From: Wolfe - DNR, Stephen <stephen.wolfe@state.co.us>
Sent: Monday, August 21, 2023 8:47 AM
To: Alex Waner
Cc: Jason Eisenach; Justin Pivik
Subject: [External]:Re: Verdad Hallet 1 Well

Steve – Below is our agreed upon updated plan for the Hallet 1 (API 05-123-05736) that we are currently plugging.

Hallet #1 Adjusted Plan WBD

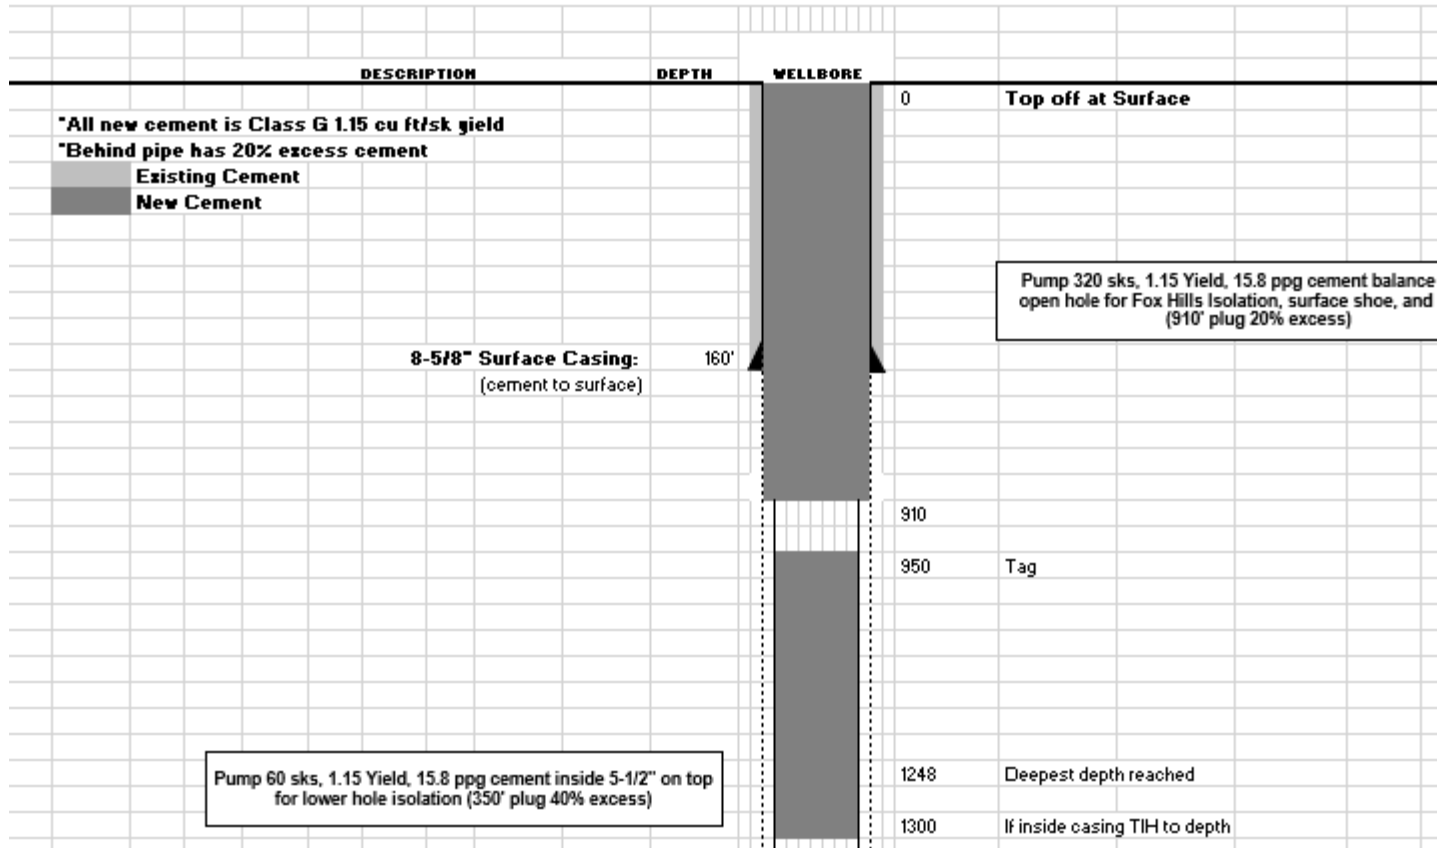
1. TOOH with 5.5" casing
2. TIH w/ 2-7/8" tubing w/ notched collar to 1300'. If able to get into exiting 5.5" casing, TIH to 1300'. If unable to get into casing, TIH to maximum depth reached @ 1248', if conditions allow
3. Pump 60 sks, 1.15 Yield, 15.8 ppg cement inside 5-1/2" for lower hole isolation. 350' plug with 40% excess
4. POOH, WOC minimum 4 hours. TIH and tag cement
5. POOH to top of 5.5" casing @ 910'
6. Pump 320 sks, 1.15 Yield, 15.8 ppg cement in 7-7/8" open hole for Fox Hills isolation and surface casing isolation. Pump in 2 stages if necessary
7. Top off and RD

Approved.
